Department of Energy

On October 7, 1991, the Yucca Mountain Quality Assurance Division (YMQAD) completed its review and approval of the Lawrence Livermore National Laboratory (LLNL) Quality Assurance (QA) Program Plan Change Notices R 1-0-3, R 1-0-4, R 3-0-5, and R 4-0-2 to 033-YMP-R.

SUBJECT: Transmittal of LLNL-YMP Quality Assurance Program Plan
Change Notice 1.0-0-3

CHANGE NOTICE

Figure 1.0.2

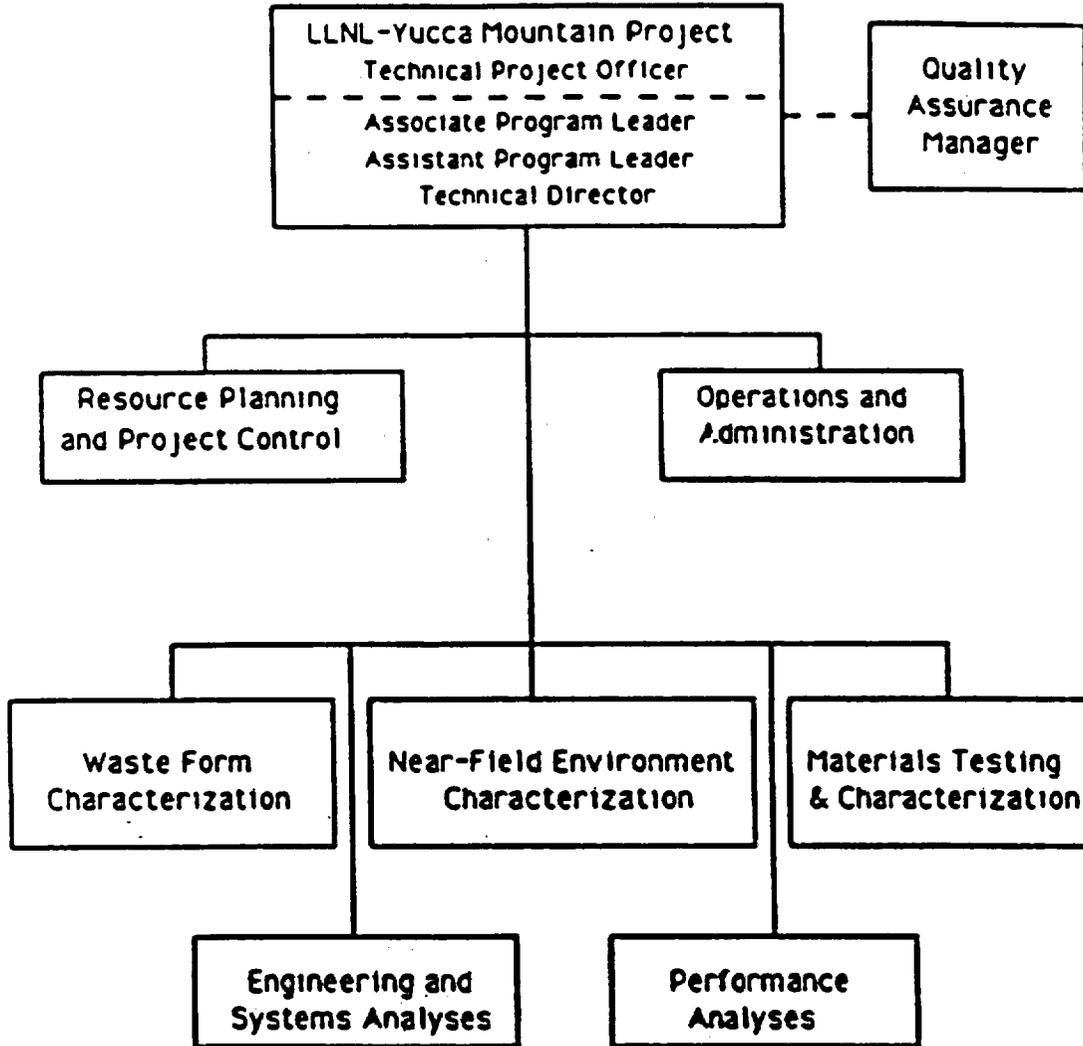
Figure 1.0.2 is changed to read as described on page 2 of this Change Notice.
Appendix is changed to read as described on page 3 of this Change Notice.
